RE: WC-0975 Final Amendment and Change Order Narrative (Backup)

OCWUT Project No. WC-0975 Airport Fire Suppression Extension Air Cargo Road, from Booster Station No. 11 to Will Rogers World Airport Terminal was successfully completed by Southwest Water Works, LLC by January 19, 2024.

AIRPORT FIRE SUPPRESSION EXTENSION
AIR CARGO ROAD

SHEET
C-13

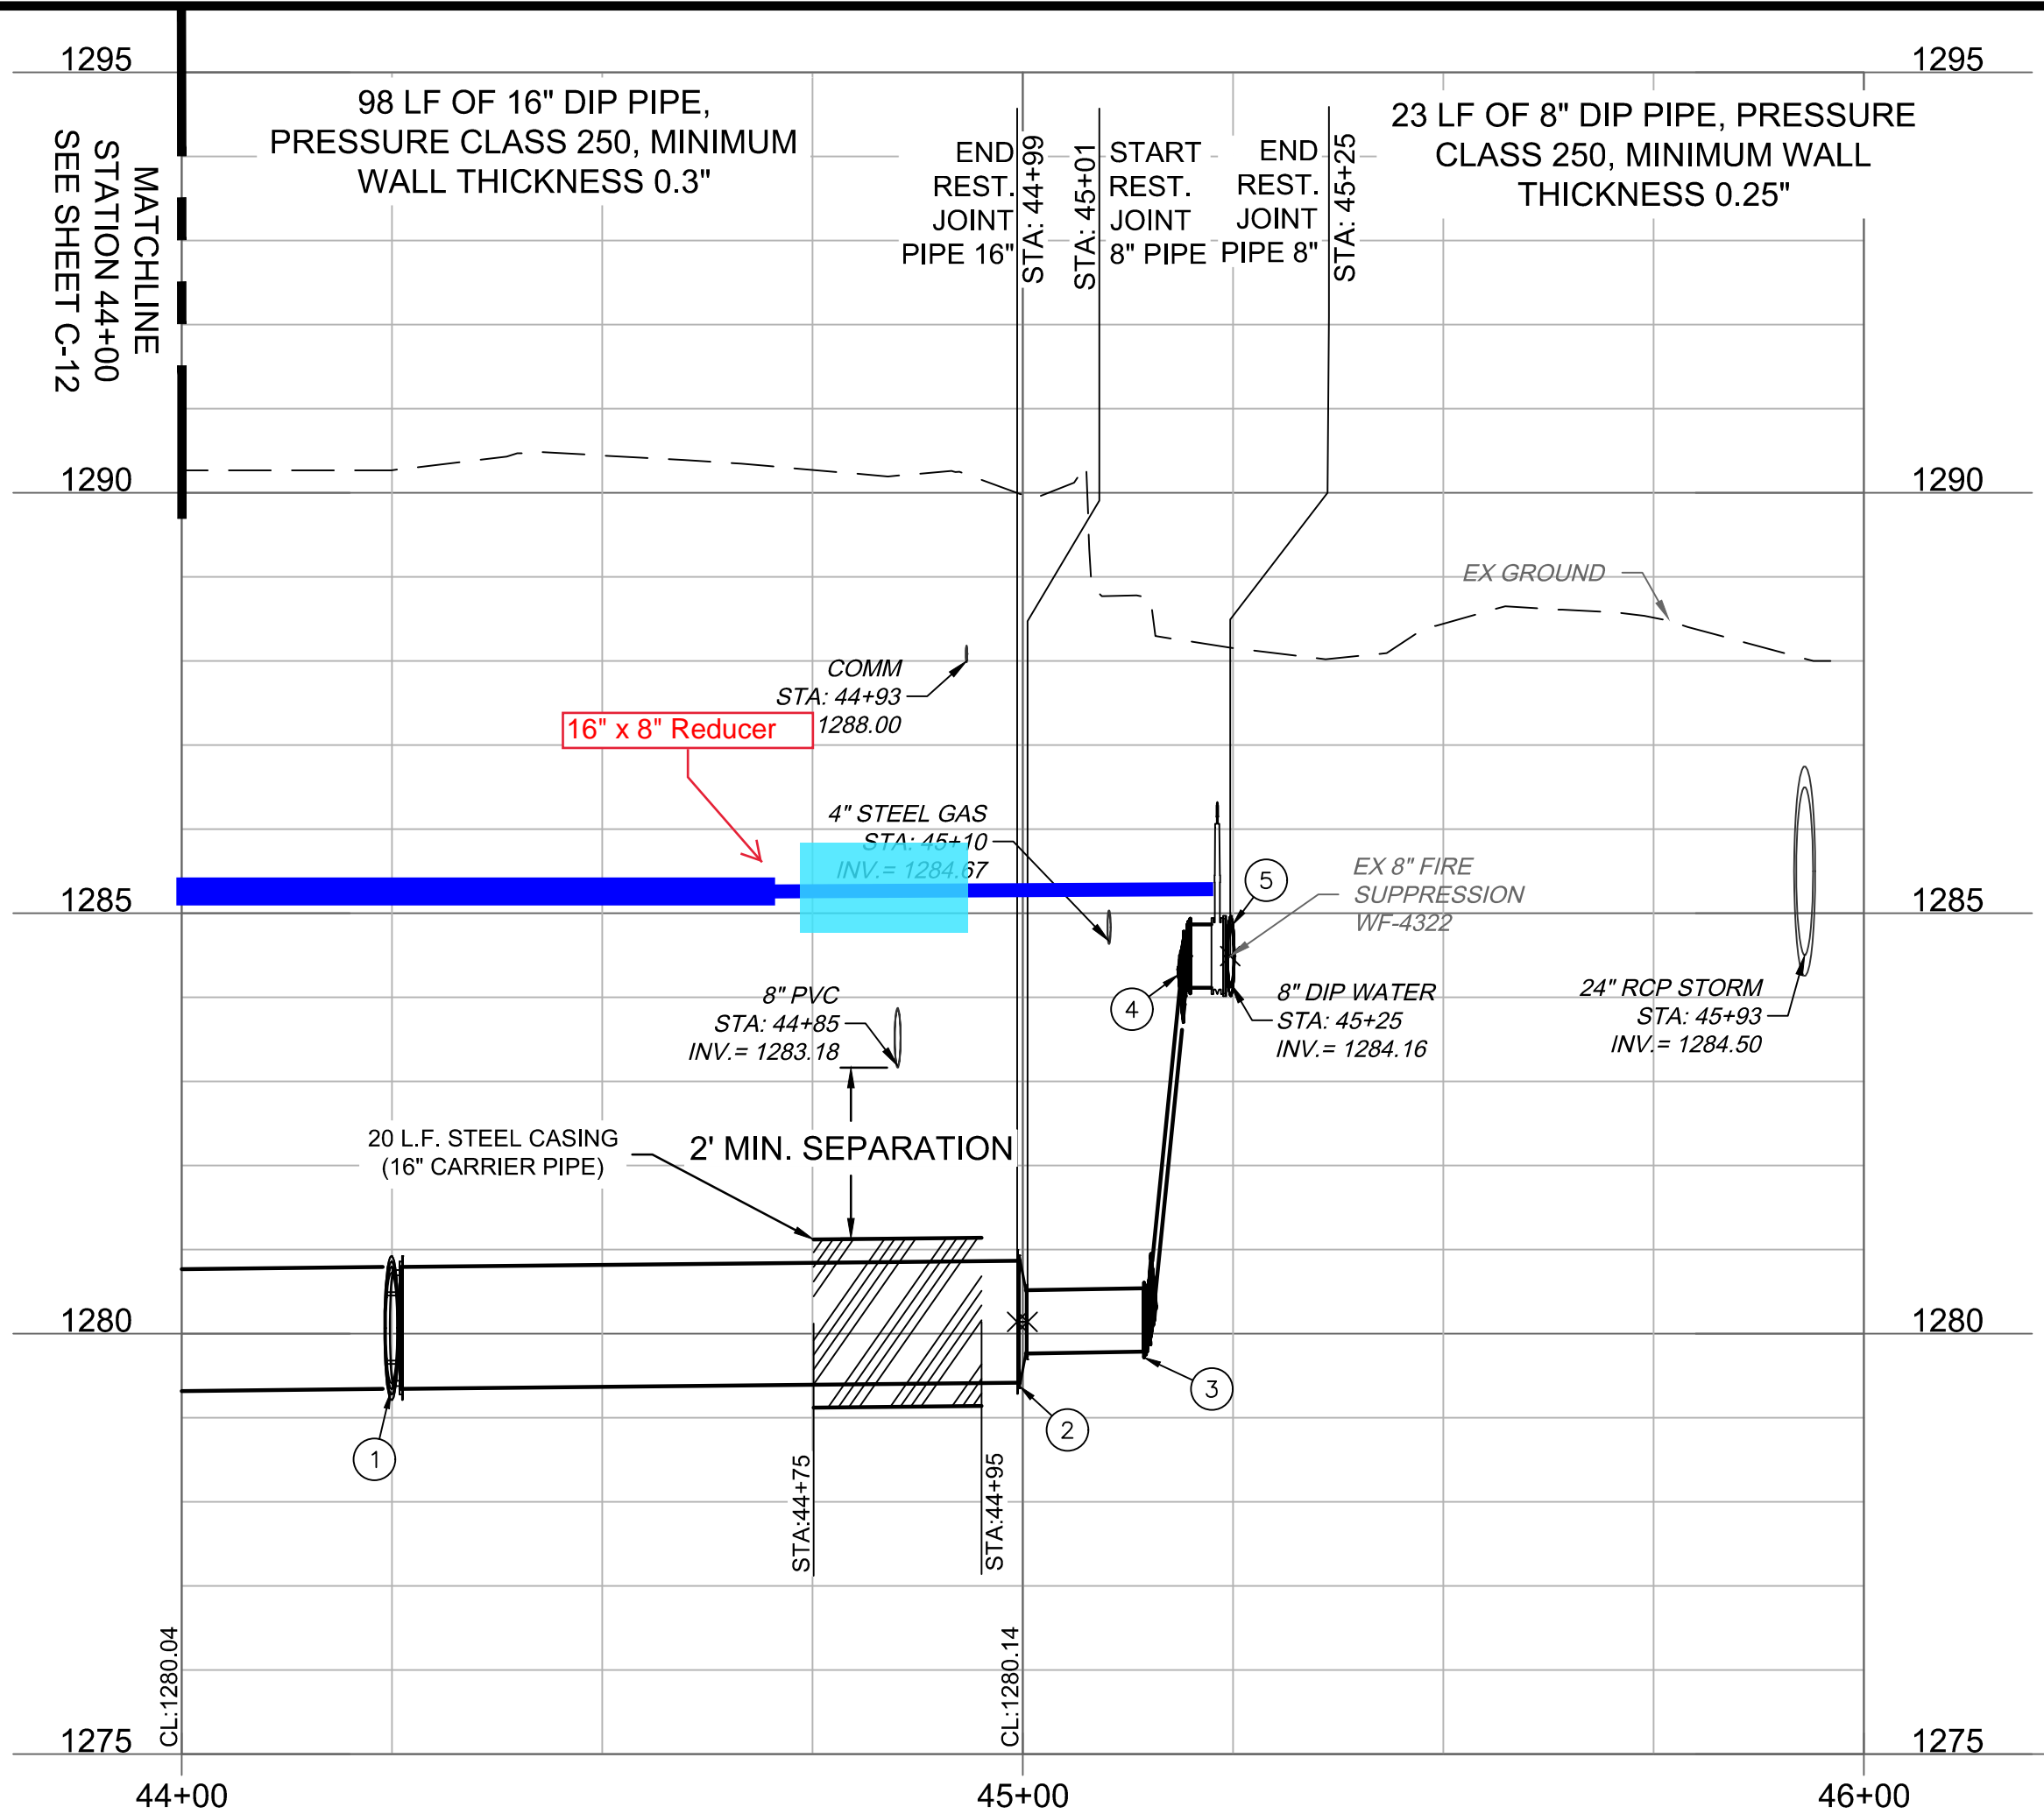
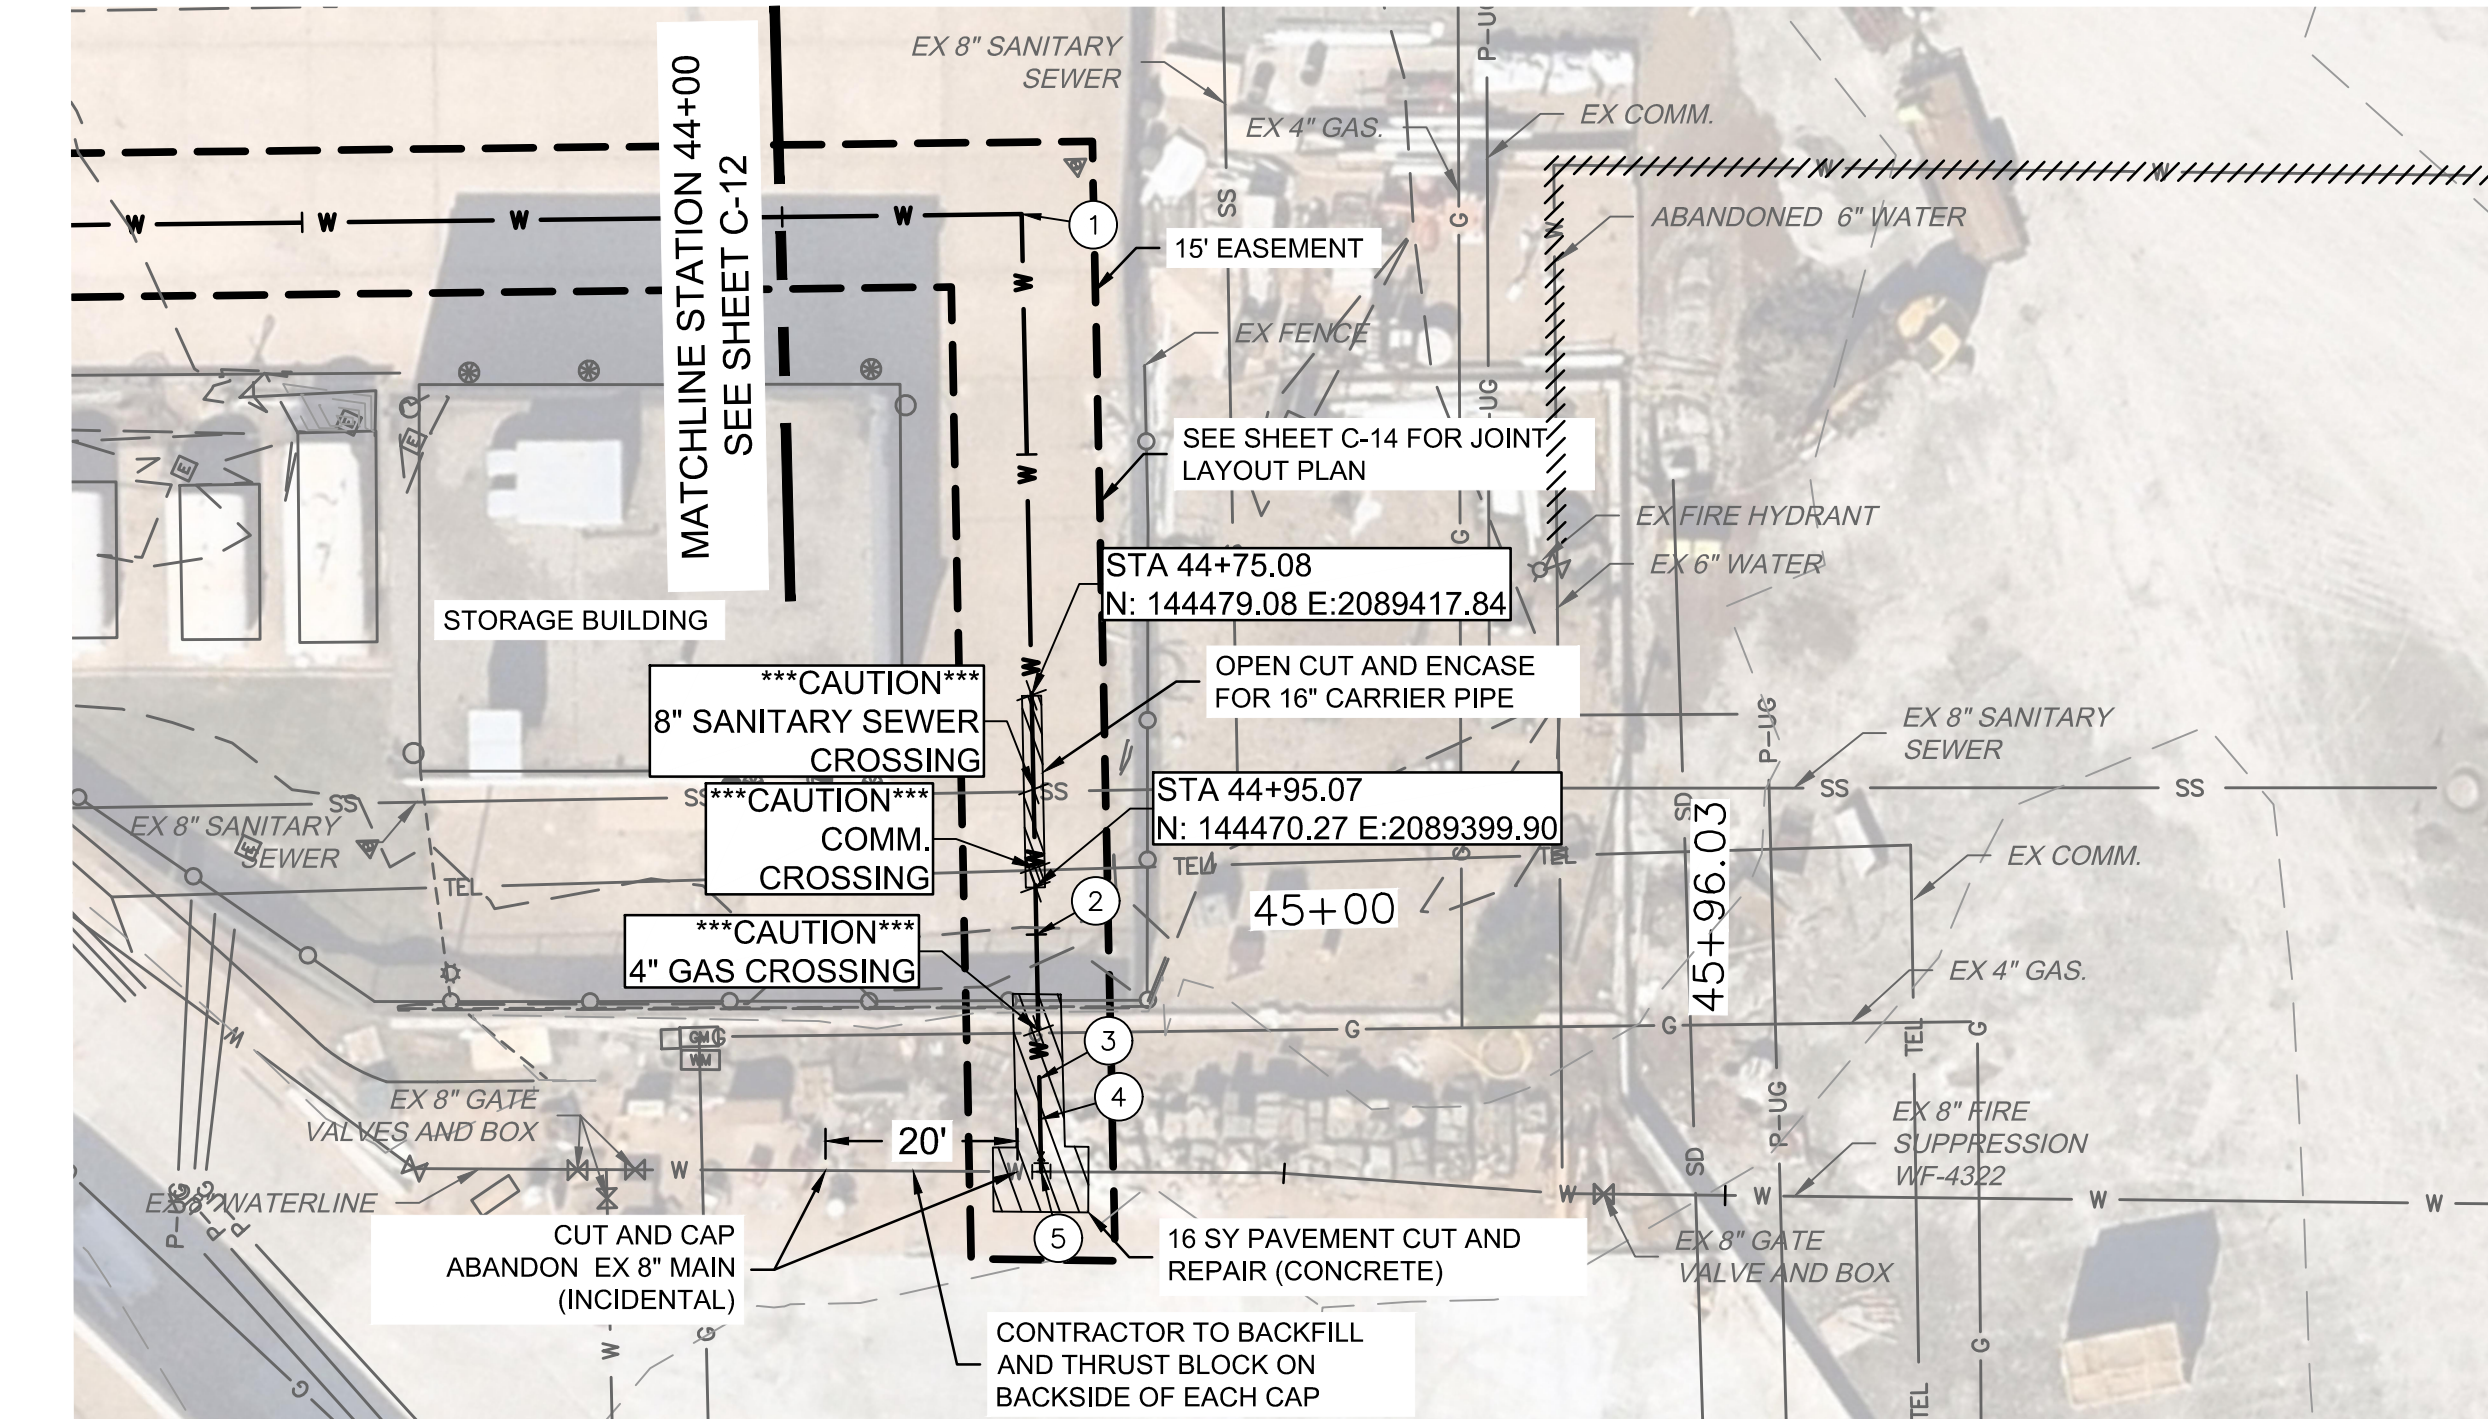
We have run into a couple of issues here at the south end of the project as there are many utilities that we have found (so far) that are in conflict with our path and will limit our excavation. As you can see there are multiple power lines as well as a duct and multiple fiber conduits (a couple of feet under the duct which are not shown in this picture), which will make it impossible for us to excavate and install pipe underneath the existing sewer main and be compliant with OSHA's trench safety guidelines. Luckily, the existing sewer main has about 6' 8" of cover, so our thought is that we extend the 8" water main and encase it over the sewer line, and then install the 16" x 8" reducer. Based on the utilities in the area I do not think it is possible for us to install casing and pipe underneath the sewer line and install fittings as shown on the plans. I hope I was able to provide you guys with a narrative and information that at least halfway makes sense. If not, feel free to call me to discuss.

Electric Lines

Multiple conduits 2'
below duct

Concrete duct

Jerry, I think all of this looks great on sheets C-12 and C-13, I will send over exact footages of how much 8" was installed tomorrow morning. The only thing we may change on C-13 is to show the tapping sleeve going away and becoming an 8" x 8" tee with a plug on the south end of it.
